VIRGINIA ELECTRIC AND POWER COMPANY
RICHMOND, VIRGINIA 23261

VIRGINIA ELECTRIC AND POWER COMPANY (DOMINION ENERGY VIRGINIA)
NORTH ANNA POWER STATION UNITS 1 AND 2
AMENDMENT FOR FLOOD PROTECTION DIKE MODIFICATION

Flood Protection Dike Modification
UFSAR Change NAPS-UCR-2013-004

SAR Change Request

Figure 1: Trench Detail for FPS and DWS Installation in Flood Protection Dike

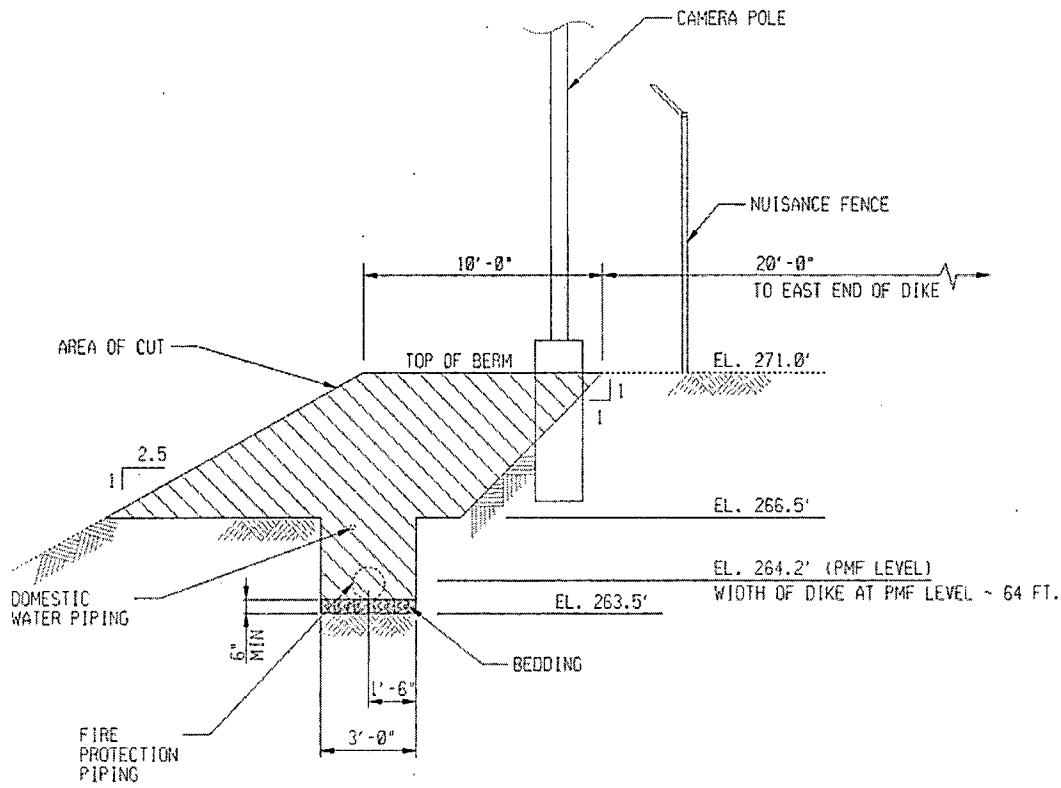
The safety-related flood protection dike, located west of the Unit 2 Turbine Building, was changed by a modification that installed two non safety-related piping systems within the flood protection dike. To facilitate the buried piping installation, a 10 ft. wide, 4.5 ft. deep trench on the western side of the flood protection dike was excavated. A smaller trench within the larger cutout was excavated for the pipes, and was 3 ft. wide by 3 ft. deep, extending the entire length of the dike. The fire protection system piping was installed to Seismic Category 1 standards at an elevation of approximately 264 feet with at least 5 feet of soil above it for tornado missile and freeze protection. Following installation of the piping, the flood protection dike was restored to its original dimensions.

A Slope Stability Analysis for the flood protection dike was performed that includes an evaluation of the flood protection dike during construction and in its final configuration. As shown in Figure 1, a 3 ft. wide by 3 ft. deep trench was excavated from the western slope and part of the crest of the dike to allow installation of the 12-inch pipe and 2-inch pipe during installation. The elevation of the domestic water system piping varies from 4 to 6 feet below the top of the flood protection dike.

Figure 9.5-1
FIRE PROTECTION SYSTEM ARRANGEMENT

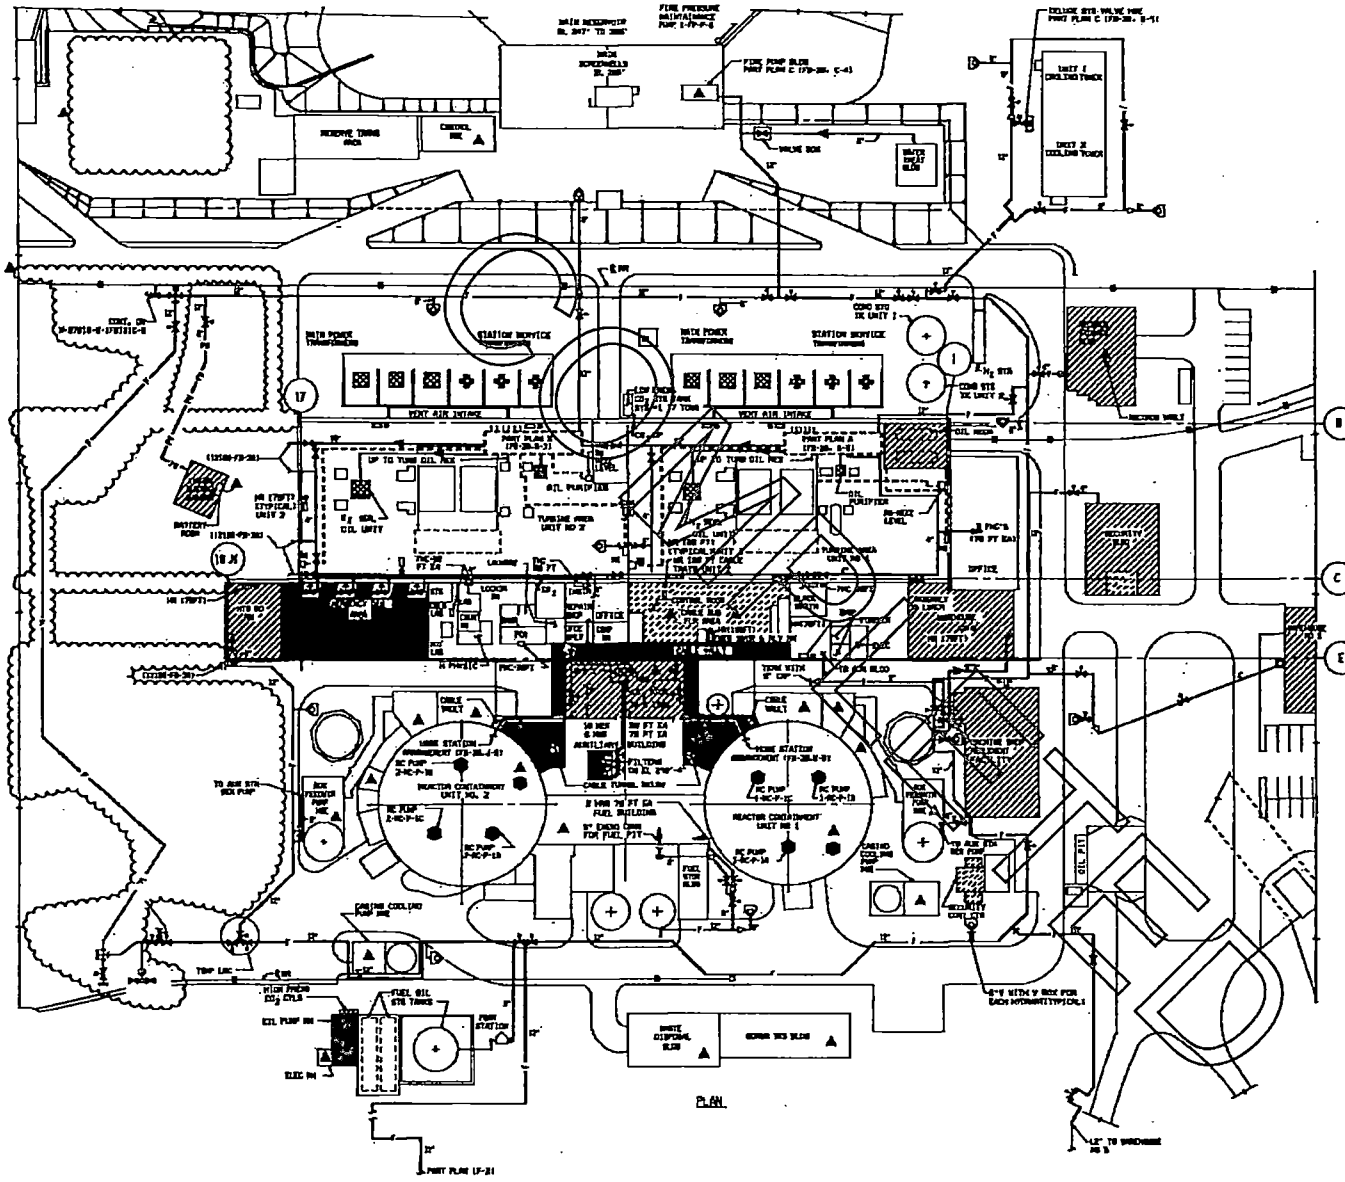
6. Source of Change: DCP 07-016 "Fire Protection and Domestic Water System Modifications/NAPS/Units 1 & 2"		
7. Description of Change UFSAR Section 3.11.3, <i>Corrosion Prevention for Underground Piping</i> , requires revision to reflect the addition of cement-lined ductile iron fire main pipe. UFSAR Table 9.2-10, <i>Domestic Water Supply Component Design Data</i> , requires revision to delete reference to Well No. 4, which is being abandoned and will add reference to Well No. 8 instead. UFSAR Section 9.5.1.1, <i>Design Basis</i> , requires revision to remove reference to the <i>Site Construction Office Building North (SCOBN) Sprinkler System</i> . UFSAR Section 9.5.1.2.1, <i>Fire Protection Water Systems</i> , requires revision to remove reference of the FPS loop going around the area formerly for Unit 3. UFSAR Figure 9.5-1, <i>Fire Protection System Arrangement</i> , requires revision due to the new fire main configuration along the west of Unit 2. Figure is also revised to remove depictions of Unit 3 structures which do not exist.

9. Basis for Change Per DCP 07-016, the current Seismic Category I fire protection pipe for the Units 1 & 2-loop will be cut/capped and abandoned in place and rerouted and replaced by cement-lined ductile iron piping so as to not interfere with the Unit 3 excavation activities. And DCP 07-016 also abandons (in place) Well No. 4, which is in the Unit 3 excavation area, while Well No. 8 will be added to replace Well No. 4. This SAR change supersedes SAR changes NAPS-UCR-2009-003 (which was originally included with DCP 07-016), SAR change NAPS-UCR-2011-013 (originated as part of DCP 07-016 FC 3 to allow a phased implementation of the SAR Changes associated with DCP 07-016) and SAR change NAPS-UCR-2012-014 (which revised Figure 9.5-1 to reflect the piping configuration at the southwest corner as issued in FC #6). SAR change NAPS-UCR-2013-004 will include the addition of Well 8 to Table 9.2-10 in the SAR changes required for DCP 07-016 and makes a minor change to Figure 9.5-1 for clarity.

The interconnection of the common yard fire main system ⁵⁰⁰ between Units 1 and 2 ^{DCP 07-016} and the ^{DCP 07-016} area formerly for Unit 3 is shown on Figure 9.5-1 and Reference Drawing 1. Units 1 and 2 are furnishing one motor-driven fire pump and one diesel-driven fire pump.
